Geology and Soils

APPENDIX F-1

GeoLabs Report Sept 14, 2018

SUBJECT: Update Geotechnical Report,
Tentative Tract Map 5658-A, North Canyon Ranch,
City of Simi Valley, California

G1

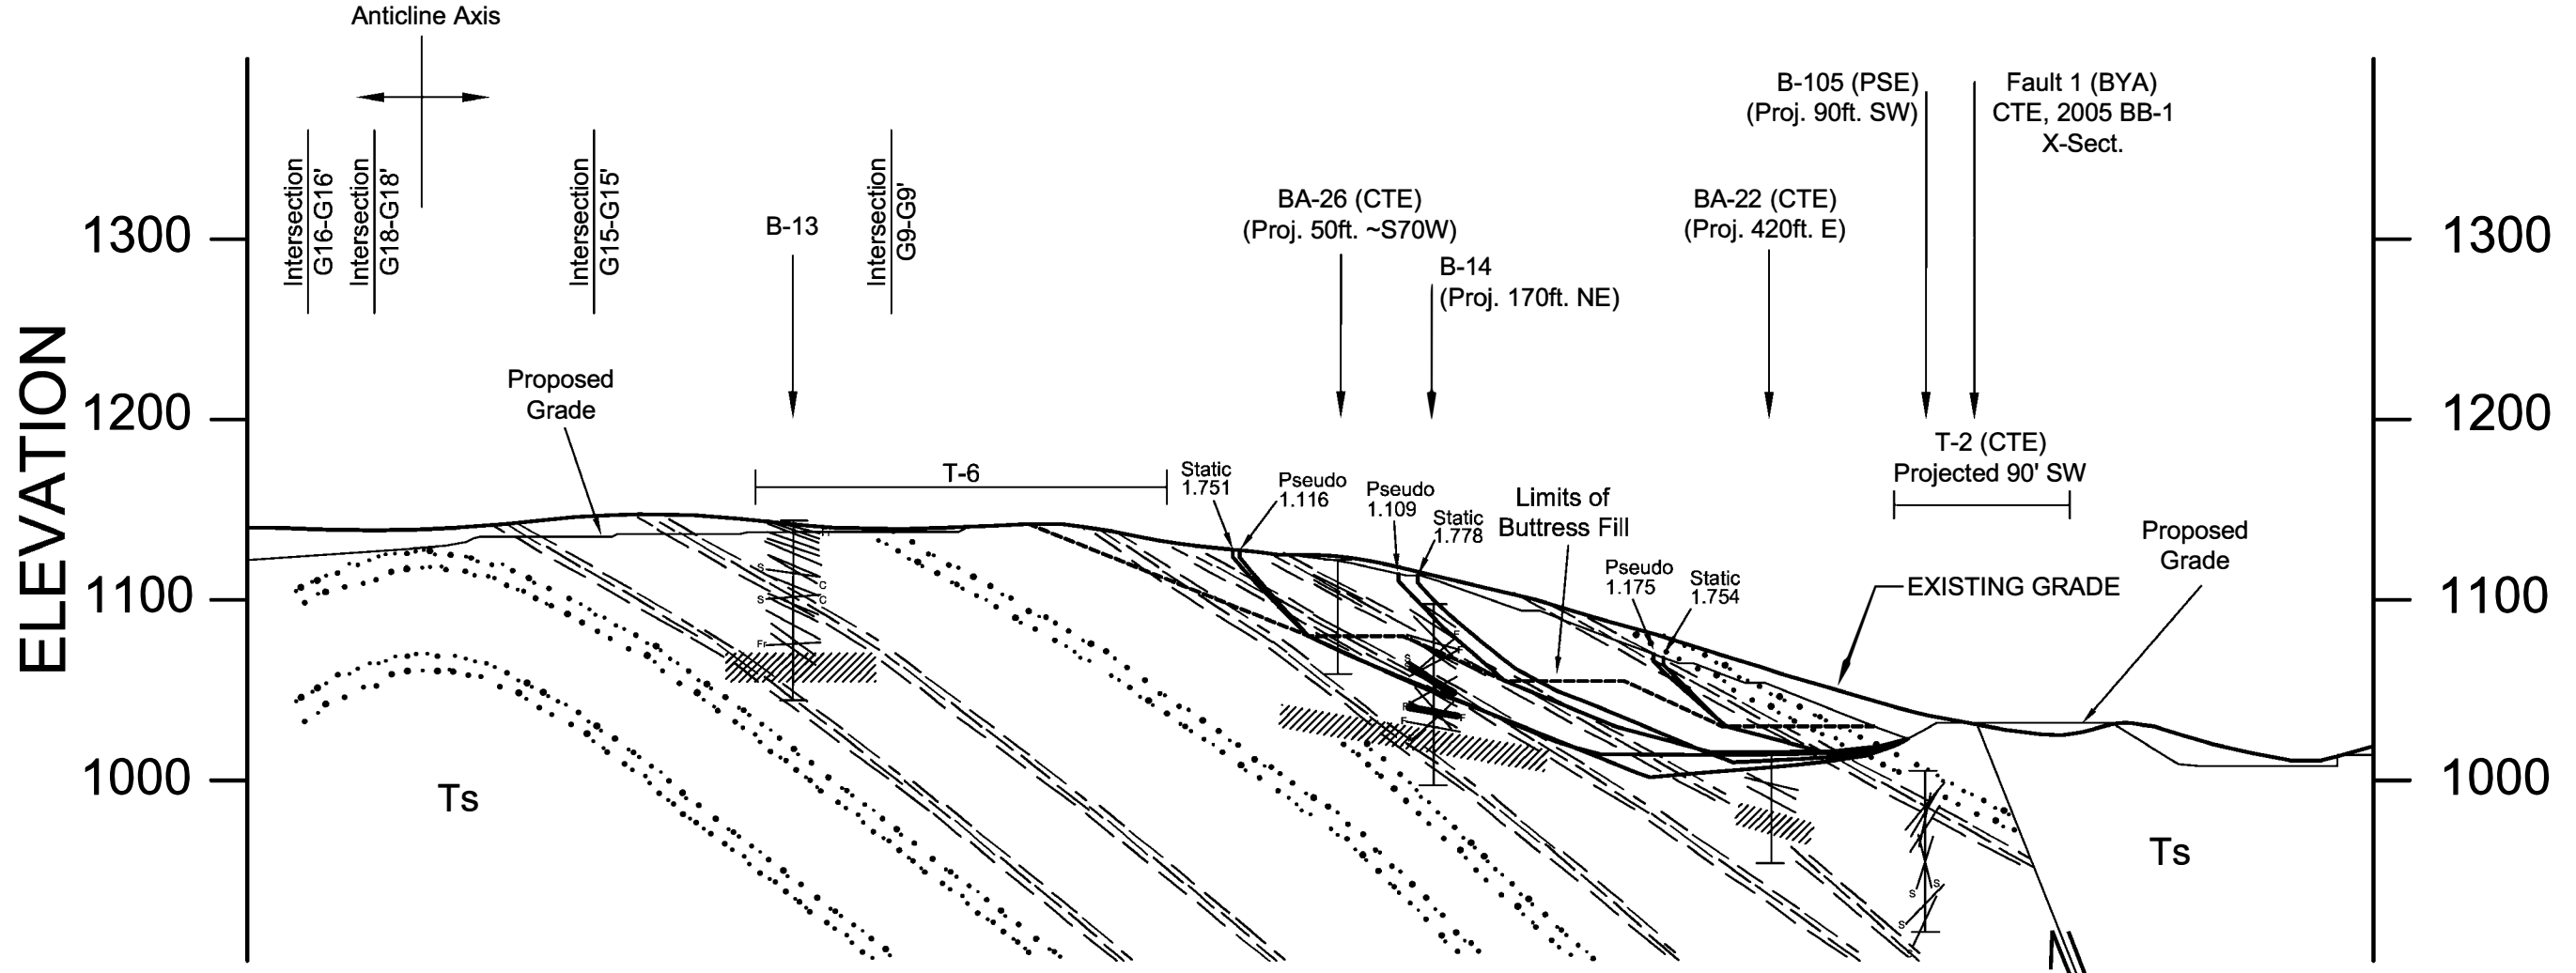
Proposed contours were provided for the central ridge buttress area illustrated in cross section G1. This configuration requires buttressing to mitigate the presence of shallow dipping fine-grained beds within the bedrock. This new buttress expands the limits of grading (see Plate 1.2). The buttress design is discussed below in the "SLOPE STABILITY" section of this report.

Slope stability analyses considering proposed grades with along-bedding failures through these layers obtained inadequate factors of safety for both static and pseudostatic conditions. A buttress was designed to partially remove these layers such that adequate factors of safety may be obtained. The upper layer should be removed to an elevation of 1030 feet, the middle layer to an elevation of 1055 feet, and the lower layer to an elevation of 1080 feet. The removal is illustrated on the cross section (see Plate 2.1) and in the output from the slope stability analyses (see Appendix A). This buttress provides the slope adequate static and pseudostatic factors of safety considering along-bedding failures through each of the fine-grained layers as indicated in the table below.

For the temporary condition exposed during construction, the portion of the backcut between the top of slope and the removal of the lower clay bed was found to be the most critical. A 2.5:1 (horizontal:vertical) gradient for this portion of the slope was found to provide an adequate factor of safety for the temporary condition of 1.417. Rotational analyses of the buttress configuration were not performed as a taller buttress was evaluated in a previous report with identical fill strengths and found to have adequate factors of safety (see GWV, 2007).

This slope and buttress configuration expands the limits of grading approximately 150 feet along the ridgeline. The anticipated limits of grading of slope stabilization have been revised on the enclosed Geologic Map (see Plate 1.2) to reflect the current buttress design.

G3

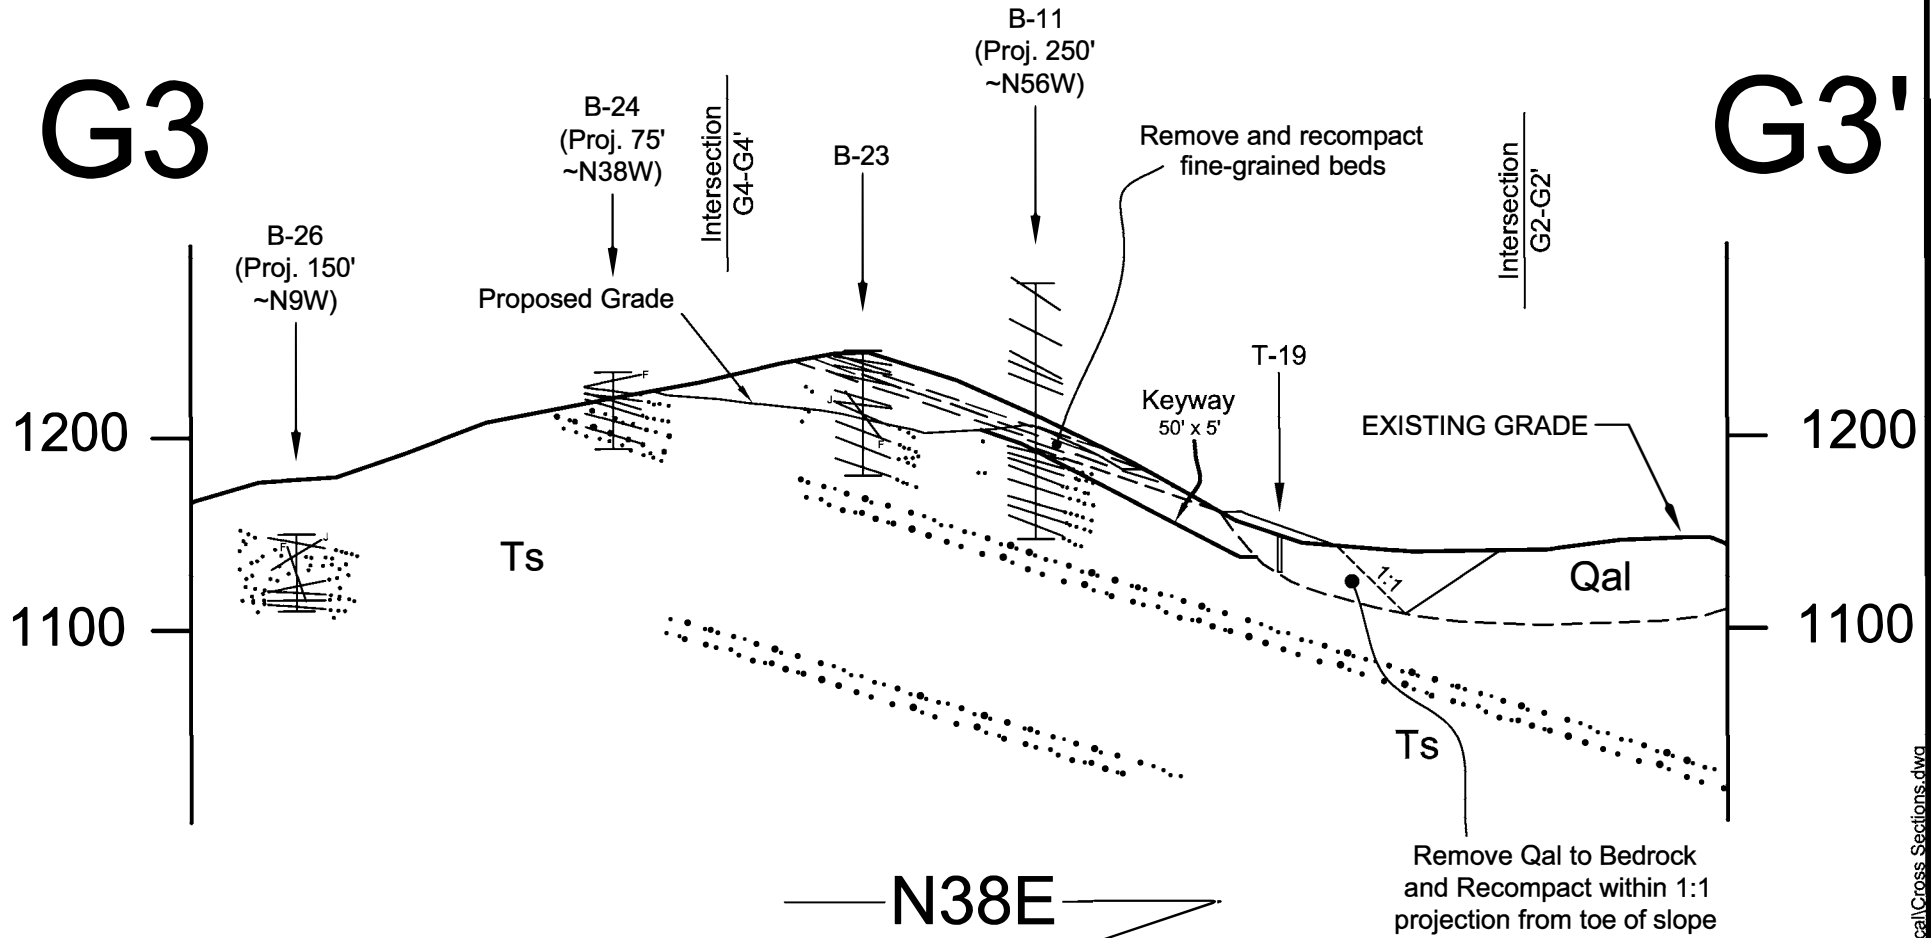
Perimeter slopes about the lots in the central canyon were revised. These are the slopes that rebuild the areas affected by removals of landslides Q1s1 and Q1s2, and the fine-grained bed removal illustrated in cross sections G3, G4, and G19. The revisions generally lower the proposed grade.

G24

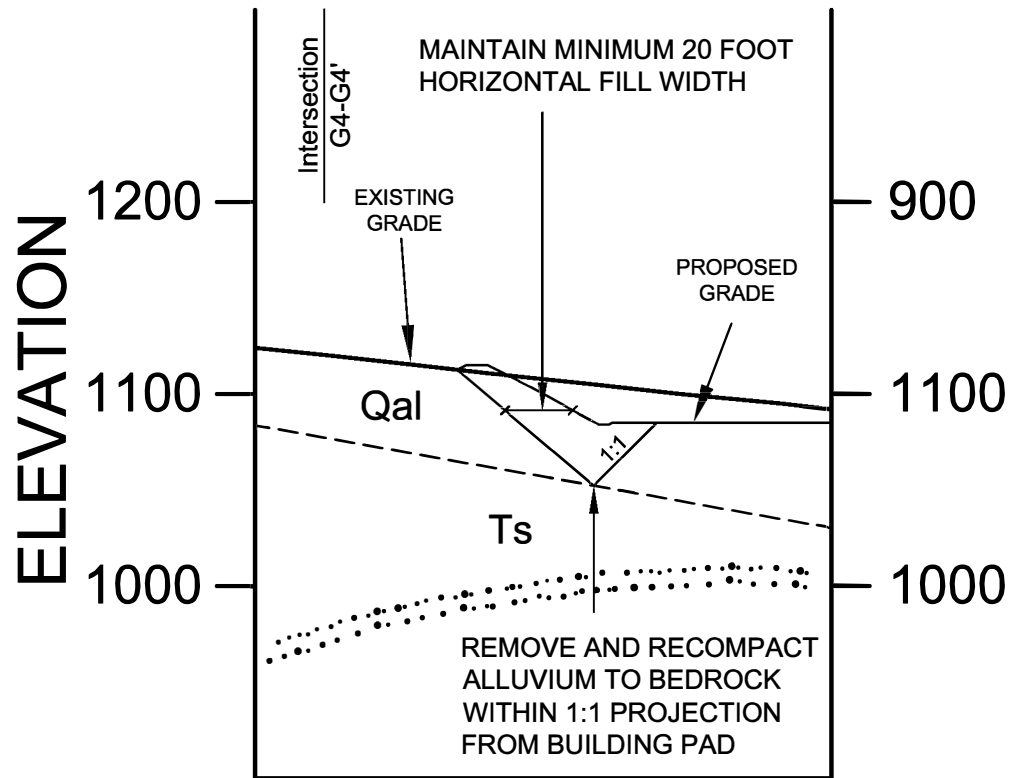
Cross section G24-G24' (see Plate 2.24) was drawn through the proposed cut slope at the north end of the central canyon behind Lots 52 to 55. This slope is anticipated to expose alluvium in the slope face and should be rebuilt as a typical stability fill per the enclosed detail (see Plate B.1). Removals of alluvium, landslide debris, or other unsuitable materials should be performed within a 1:1 projection from the edge of the building pads as illustrated in the cross section.

CASE 1 - R&R

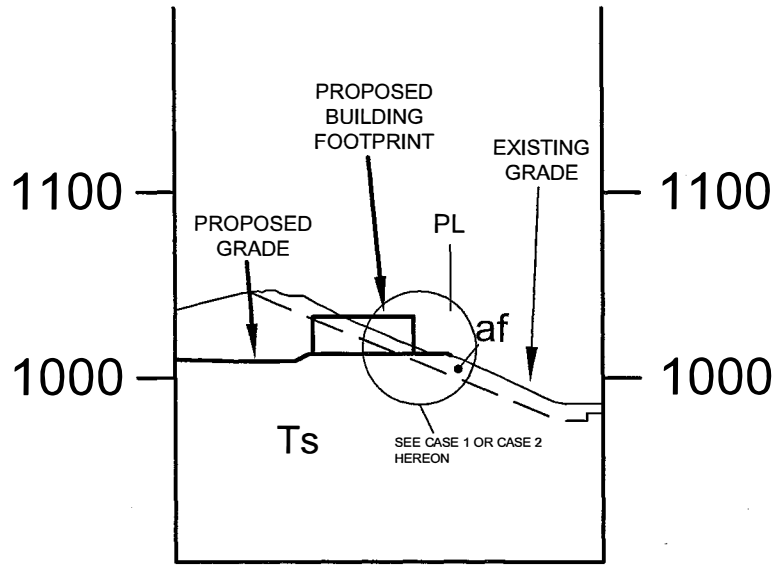
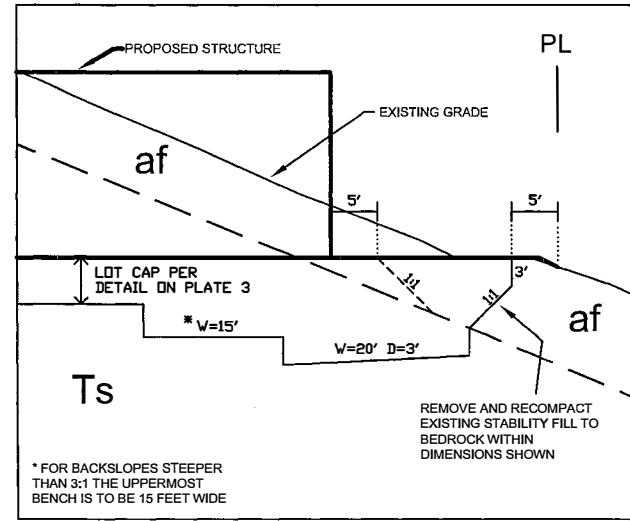
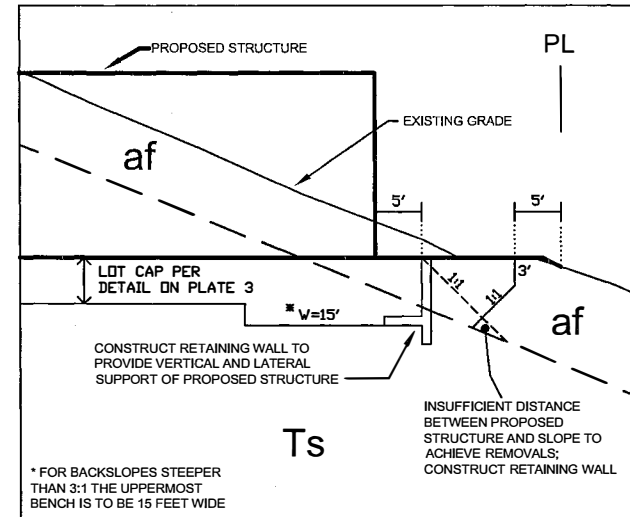
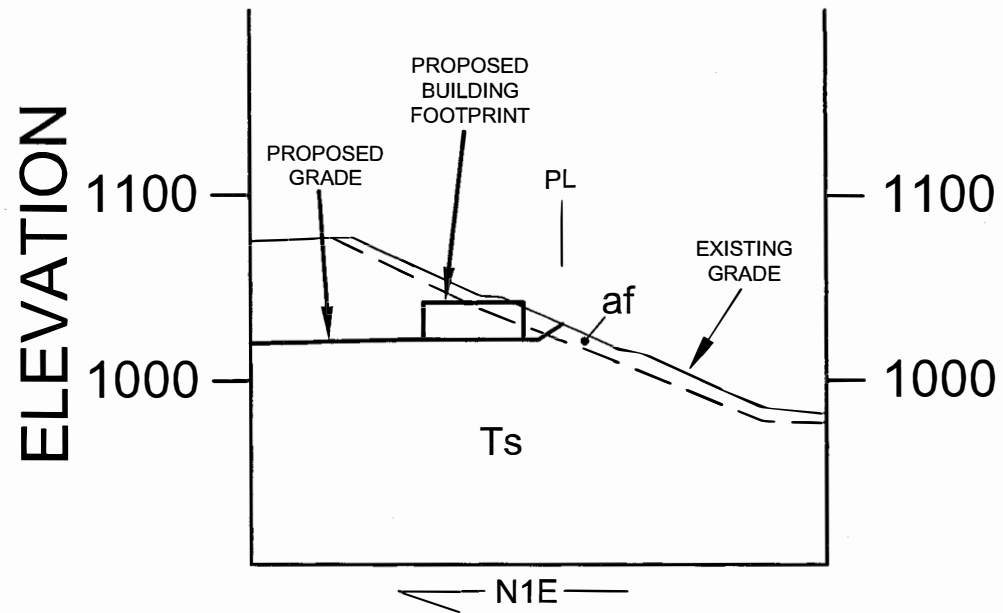
- The consultant states that "portions" of the southerly descending slope were rebuilt as a stability fill to *"mitigate stability concerns due to a clay seam (CTE 2004)"*. Based on the map, it appears that the entire slope is constructed of artificial fill. The consultant should provide a more in-depth discussion of the geotechnical conditions that required stabilization and the limits of the stability fill.

- The consultant presents a discussion of the stability fill configuration presented by CTE on Cross Section CC-CC' and concludes that the configuration depicted is not acceptable and should be verified during the grading plan stage of development. The reviewers concur with the consultant's assessment regarding the fill configuration. The reviewers are also concerned that the cross section as presented by CTE does not reflect the shallowing of dip in the axial region of the syncline observed nearby. The recommended exploration should be sufficient not only to assess the fill configuration; but further to verify that the dip inclinations remain steeper than the slope. Should dip inclinations shallower than the slope be encountered, exploration should continue to sufficient depth to verify that low-strength lithologies are not present within vertical limits that could influence the slope stability analysis.

We have developed two cross sections, A1 and A2 (see Plates 2.1 and 2.2), to illustrate simple methods available to address the Slope Issue along the south side of the apartment site. The section locations are indicated on the attached Geologic Map, Plate 1. They consider a case where portions of

the stability fill are anticipated to remain beneath the planned pad (A1), and a case where it is not (A2). Mitigation via removal and recompaction, with and without additional support from a buried retaining wall, are illustrated in the case where mitigation is required, A1. This represents but one concept to mitigate impacts from the Slope Issue for the purpose of illustrating project feasibility without offsite work; other viable concepts may be considered for value engineering purposes.
